# SALISBURY PARK NORTH PHASE 1

## TOWN OF PARKER SITE PLAN

NOVEMBER 22, 2024

**G-000**  
SITE PLAN SUBMITTAL  
Page 1 of 311

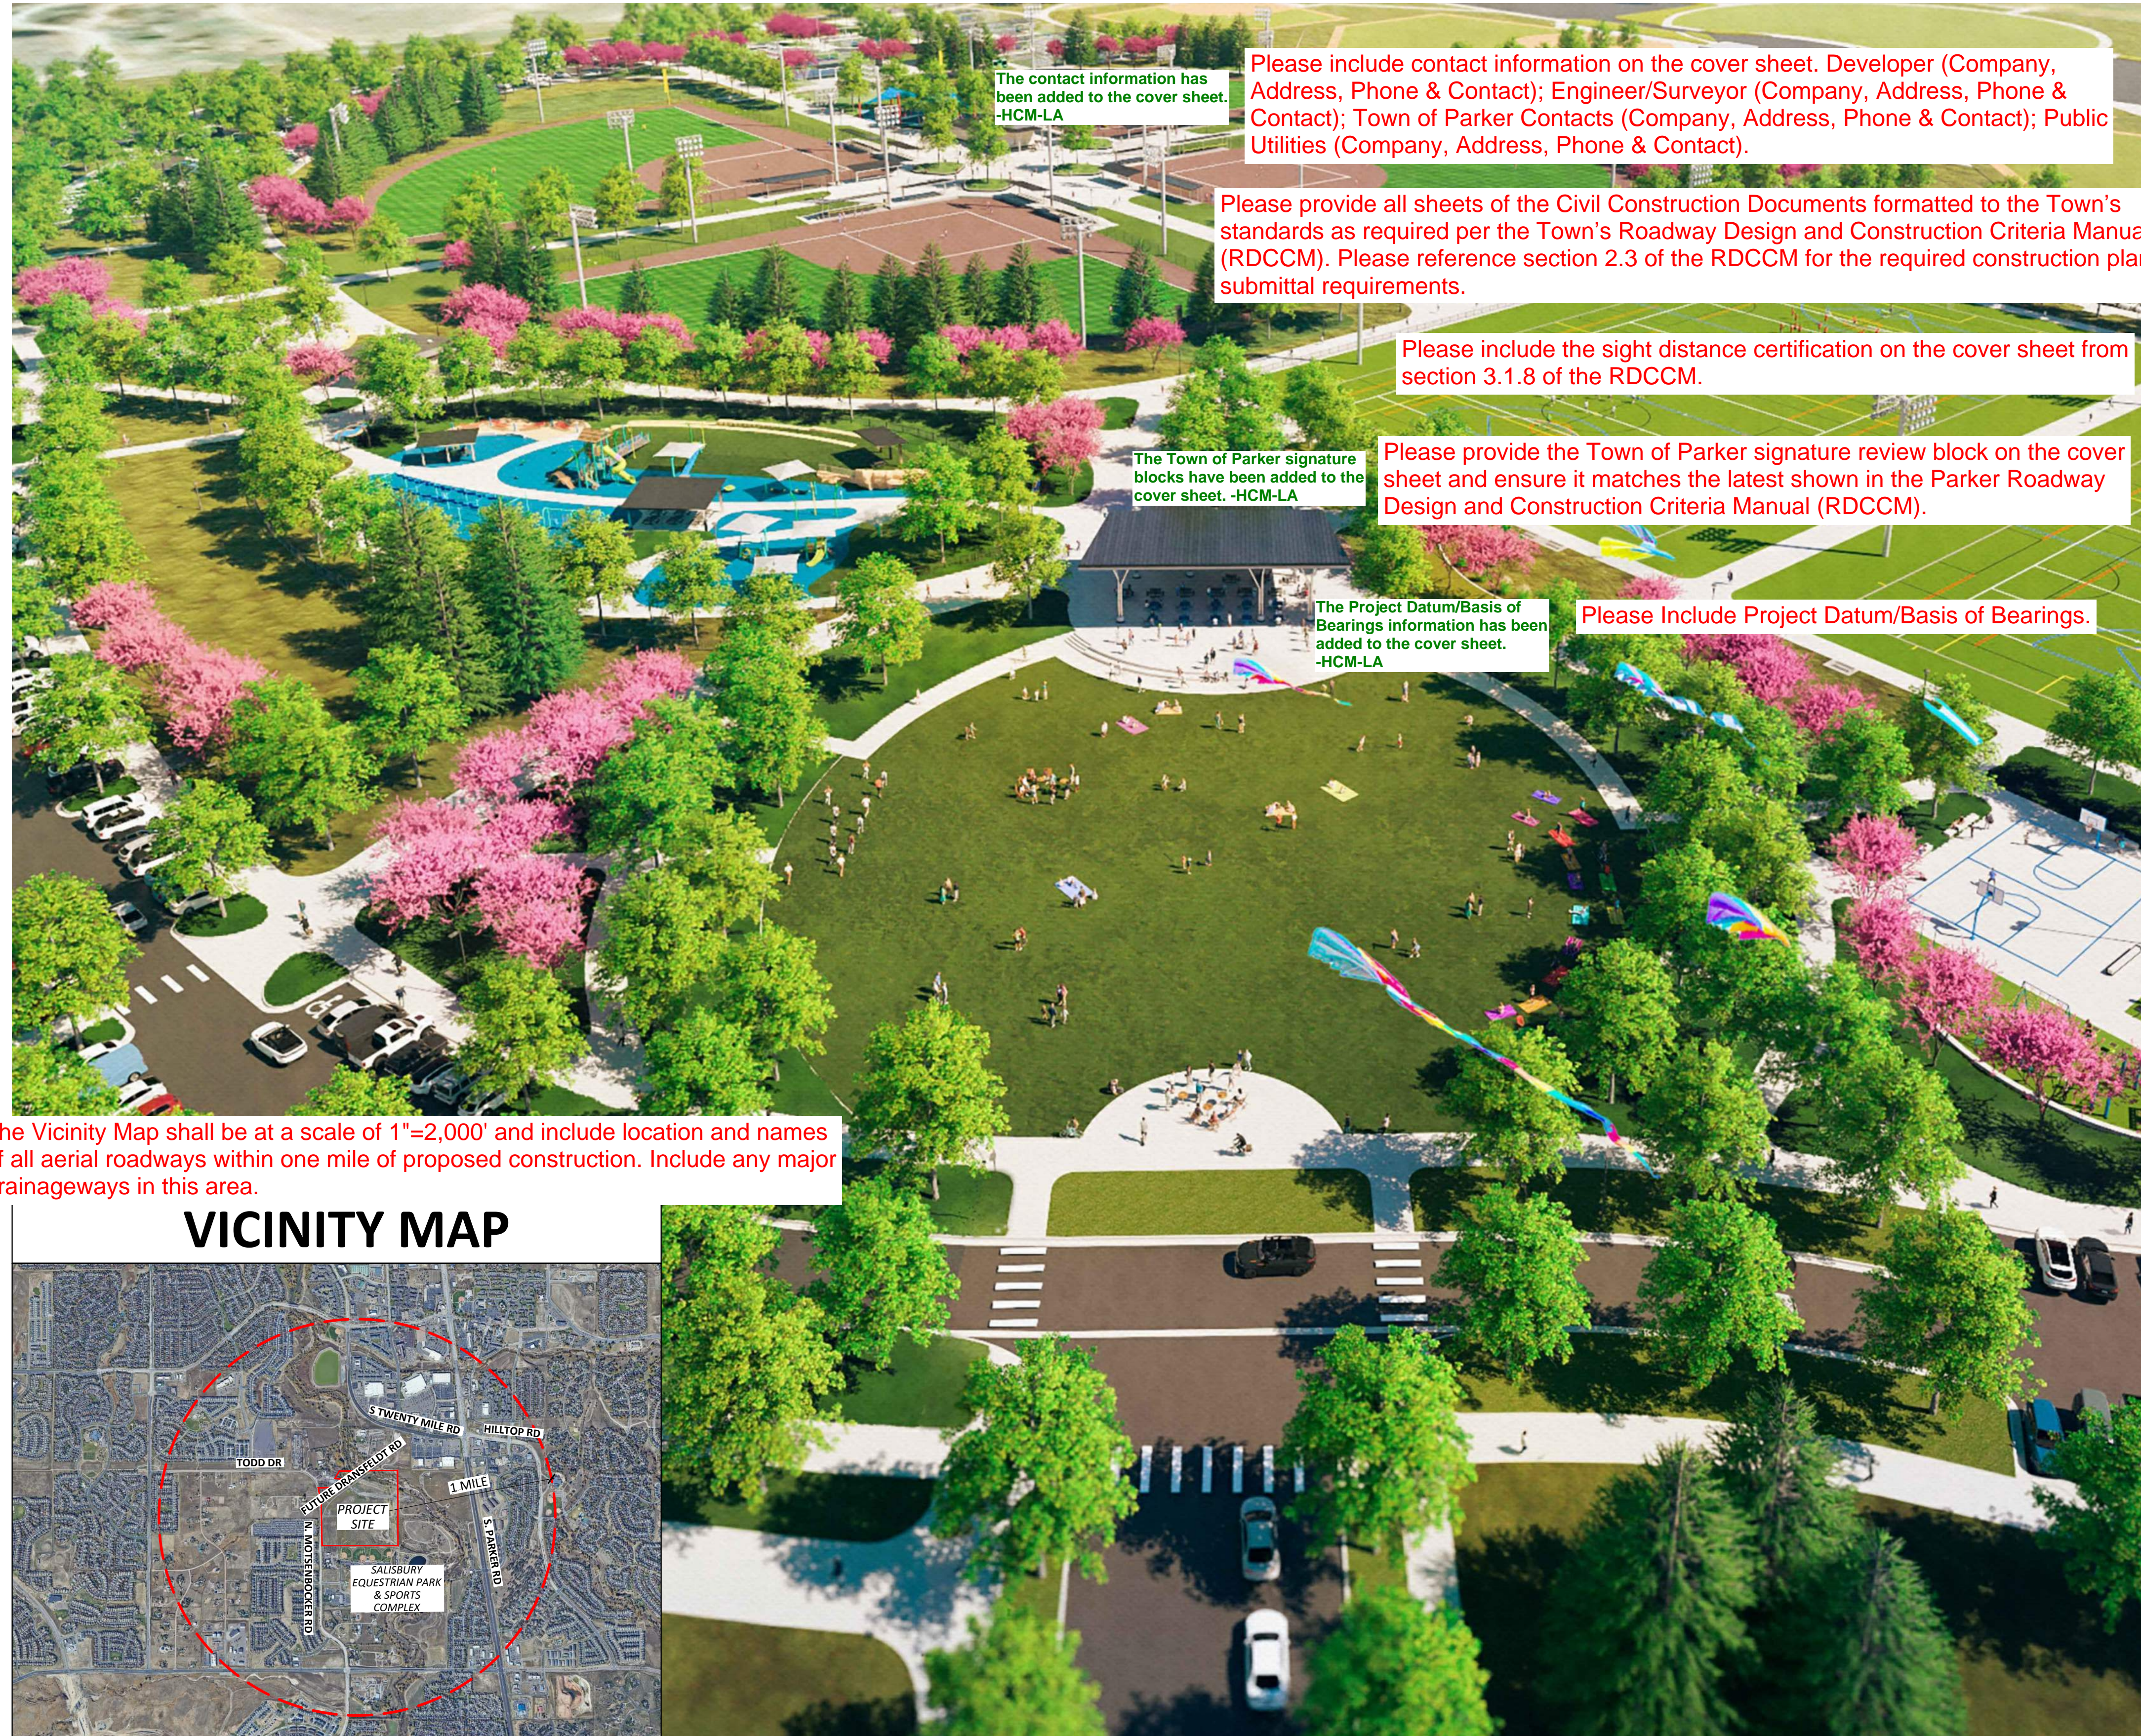
Please include contact information on the cover sheet. Developer (Company, Address, Phone & Contact); Engineer/Surveyor (Company, Address, Phone & Contact); Town of Parker Contacts (Company, Address, Phone & Contact); Public Utilities (Company, Address, Phone & Contact).

Please provide all sheets of the Civil Construction Documents formatted to the Town's standards as required per the Town's Roadway Design and Construction Criteria Manual (RDCCM). Please reference section 2.3 of the RDCCM for the required construction plan submittal requirements.

Please include the sight distance certification on the cover sheet from section 3.1.8 of the RDCCM.

Please provide the Town of Parker signature review block on the cover sheet and ensure it matches the latest shown in the Parker Roadway Design and Construction Criteria Manual (RDCCM).

Please Include Project Datum/Basis of Bearings.

The Vicinity Map shall be at a scale of 1"=2,000' and include location and names of all aerial roadways within one mile of proposed construction. Include any major drainageways in this area.

Drawing  
**OVERALL GRADING & DRAINAGE PLAN (FINAL)**

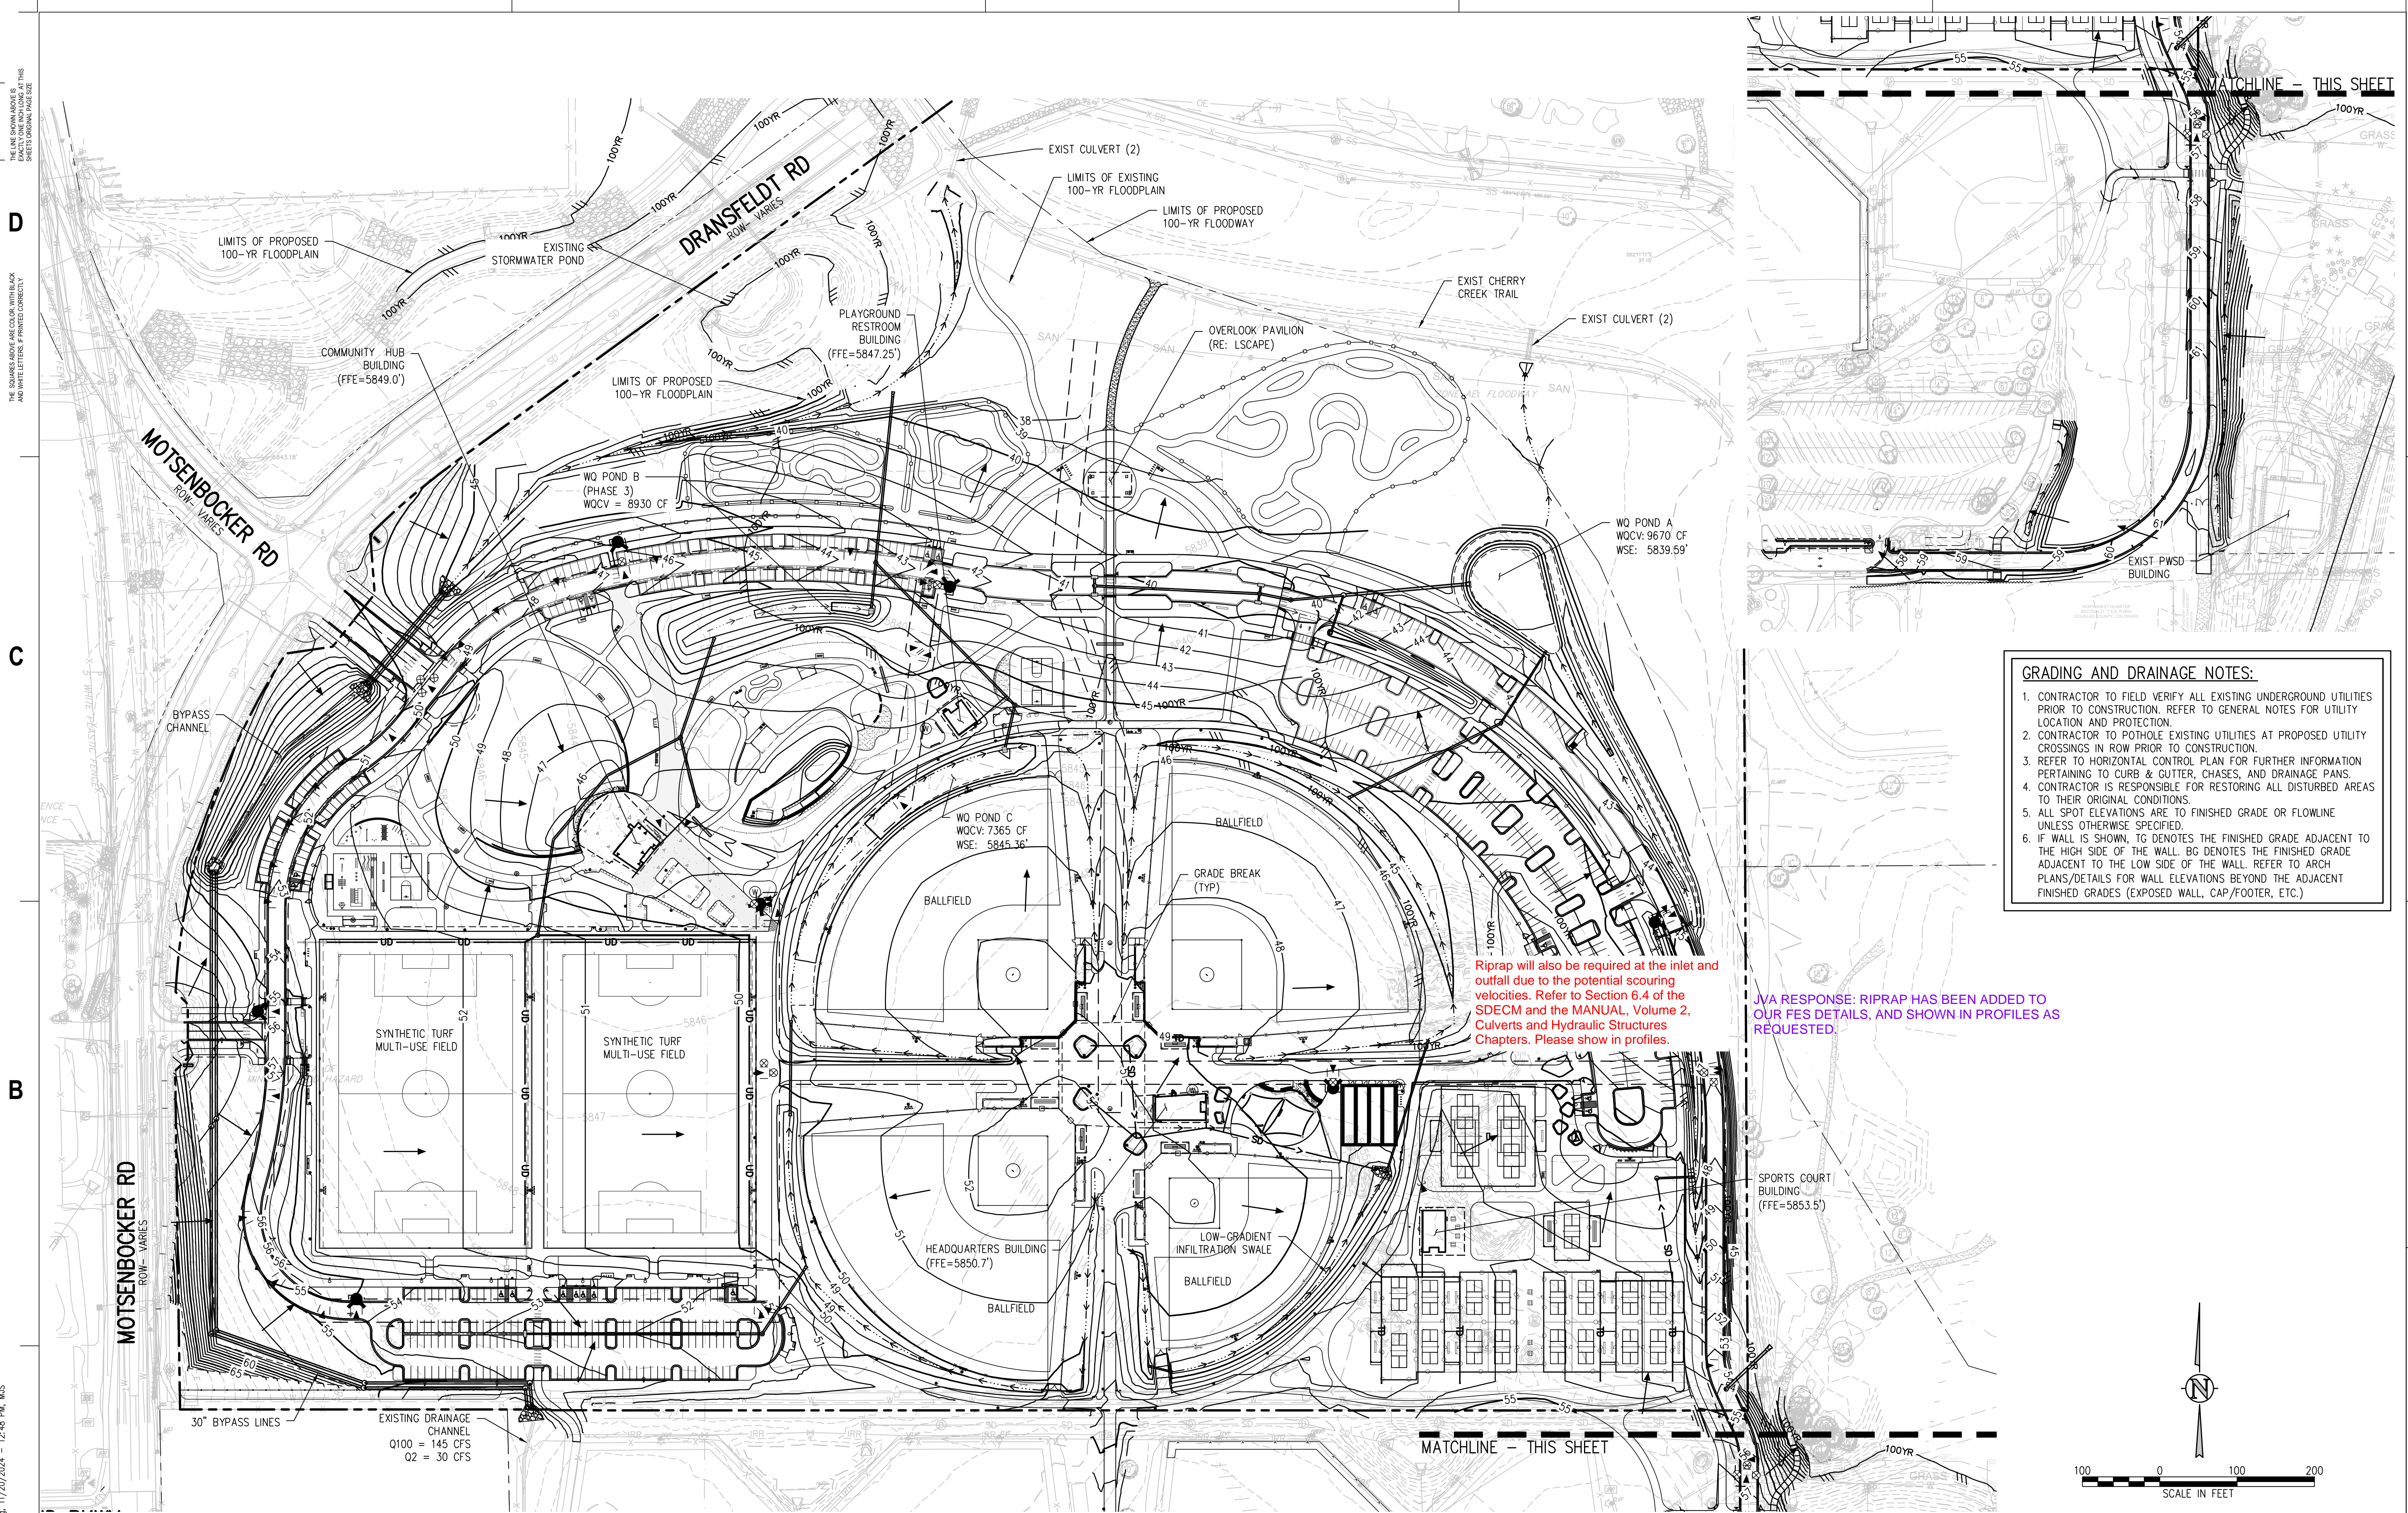
Riprap will also be required at the inlet and outfall due to the potential scouring velocities. Refer to Section 6.4 of the SDECM and the MANUAL, Volume 2, Culverts and Hydraulic Structures Chapters. Please show in profiles.

JVA RESPONSE: RIPRAP HAS BEEN ADDED TO OUR FES DETAILS, AND SHOWN IN PROFILES AS REQUESTED.

**STORM MANHOLE DETAIL** (2)

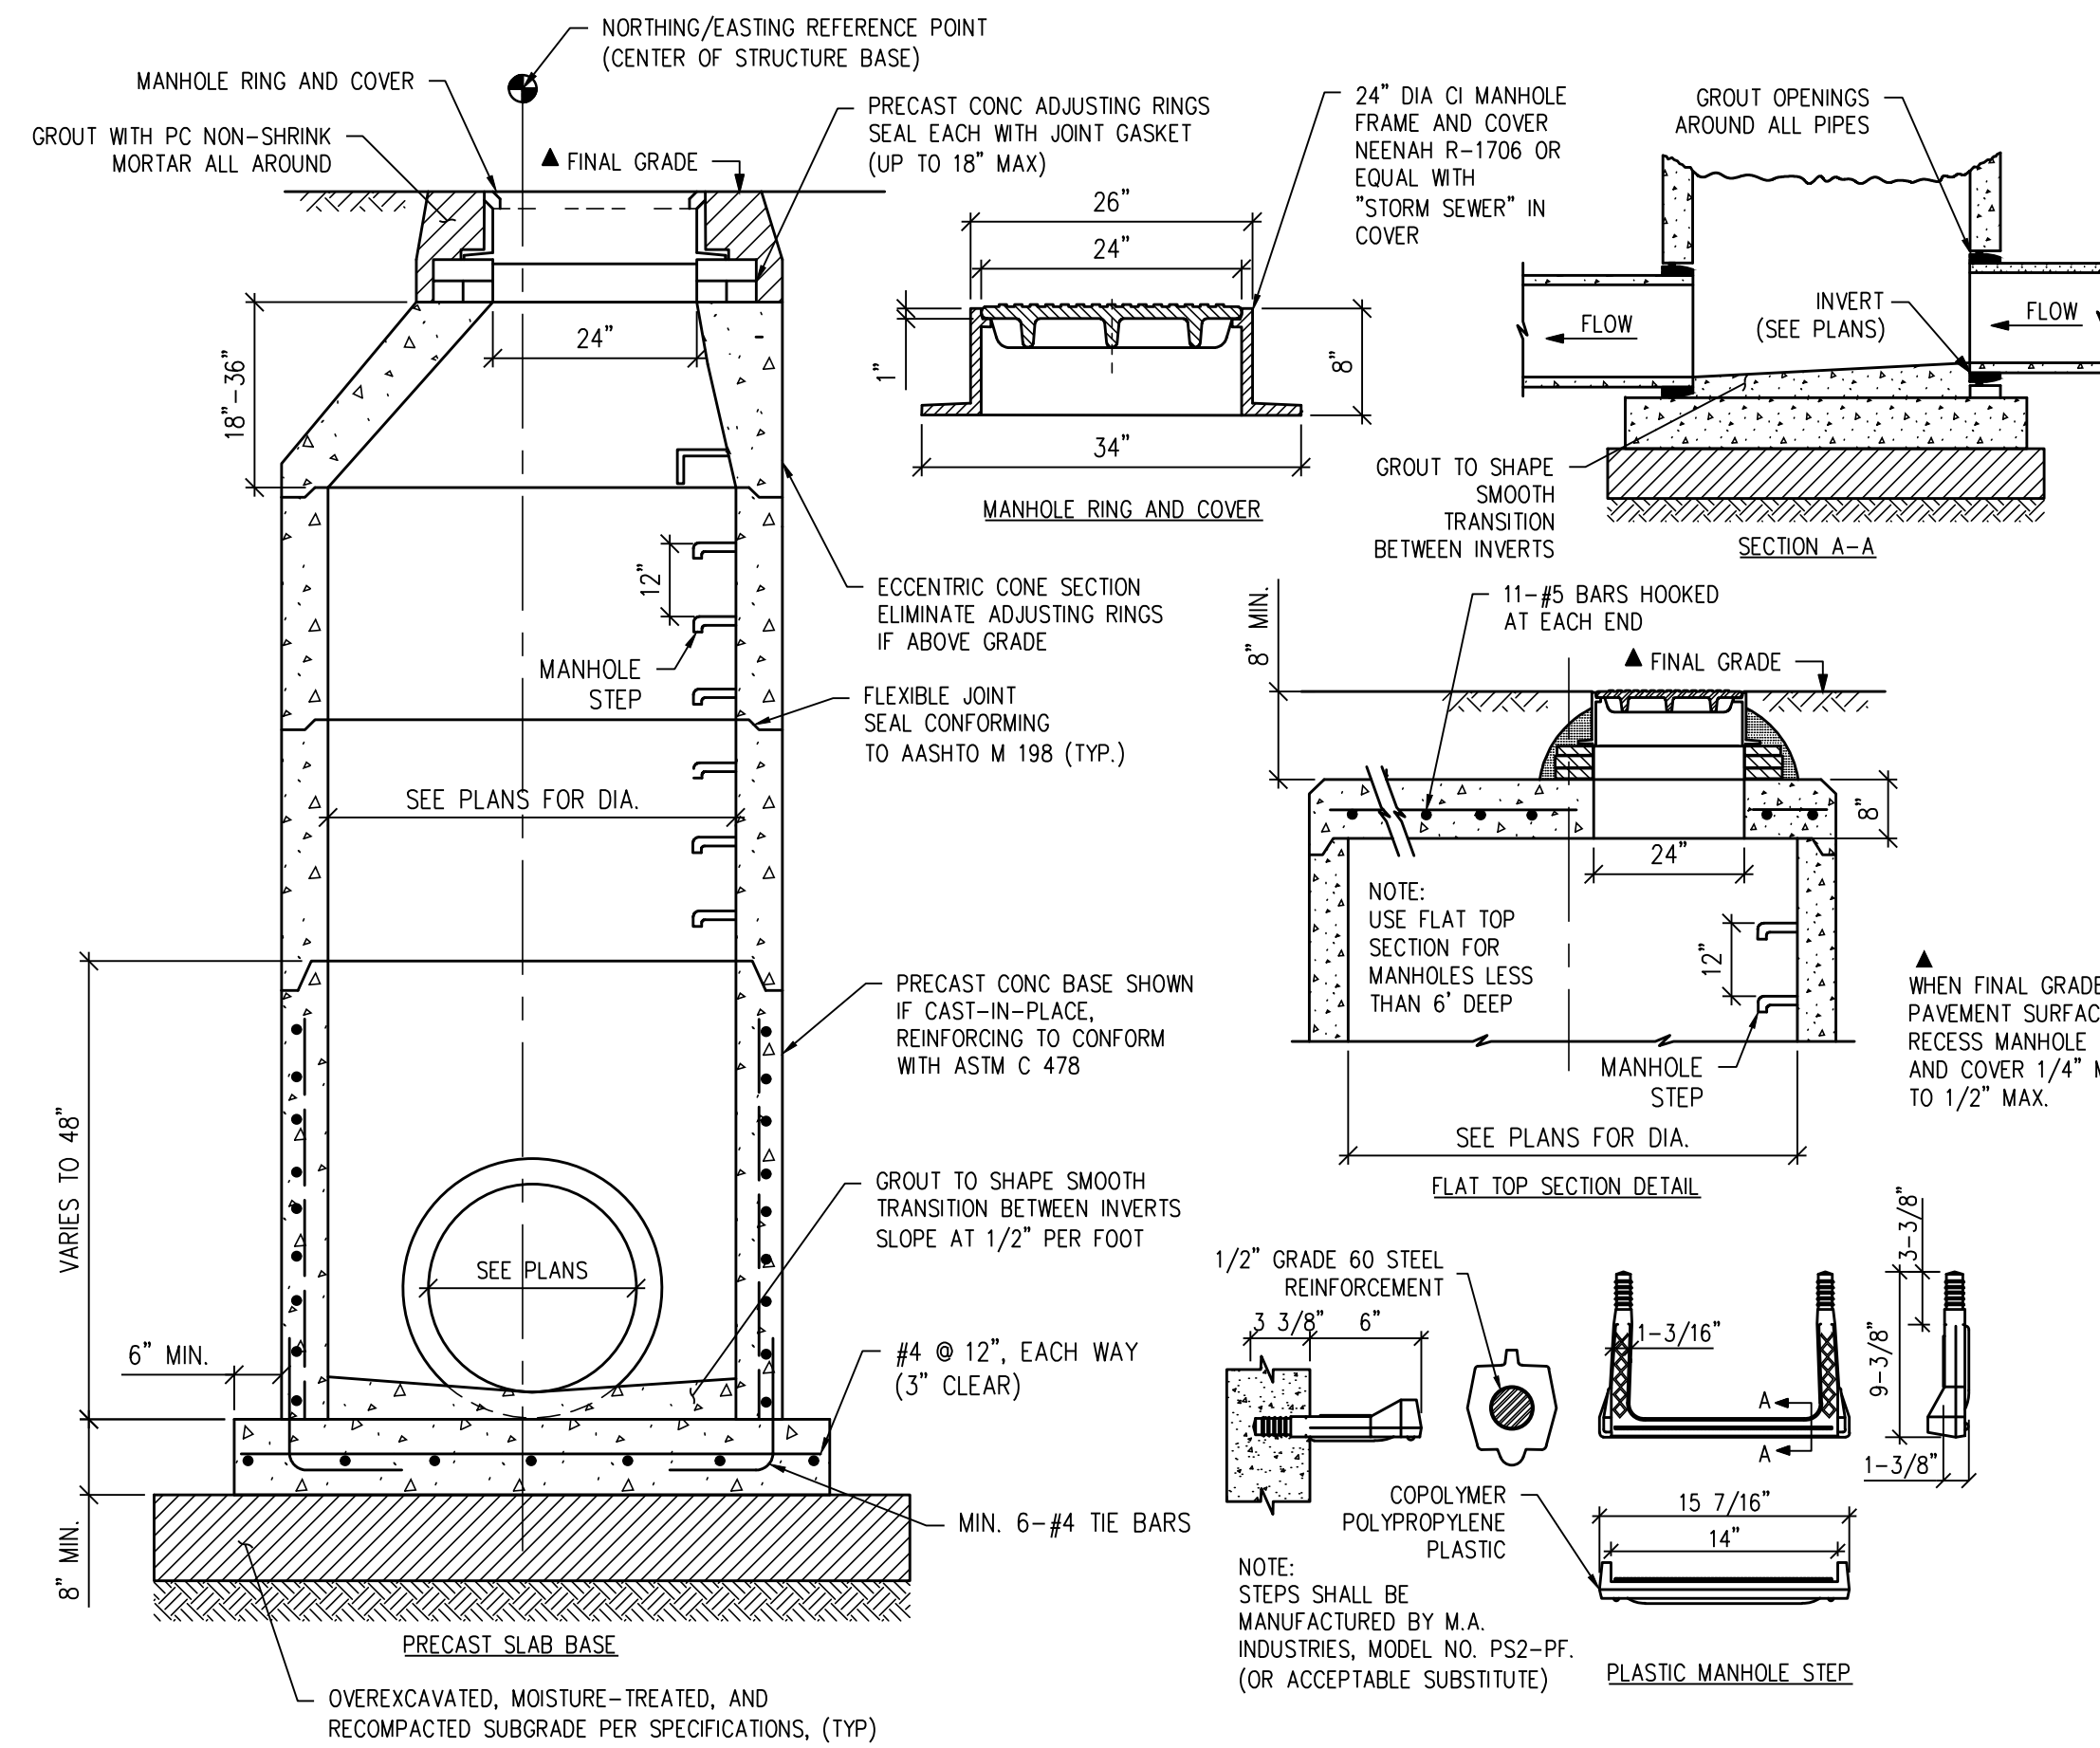
Include Parker Standard Detail 33 from the RDCCM for Manhole Cover.
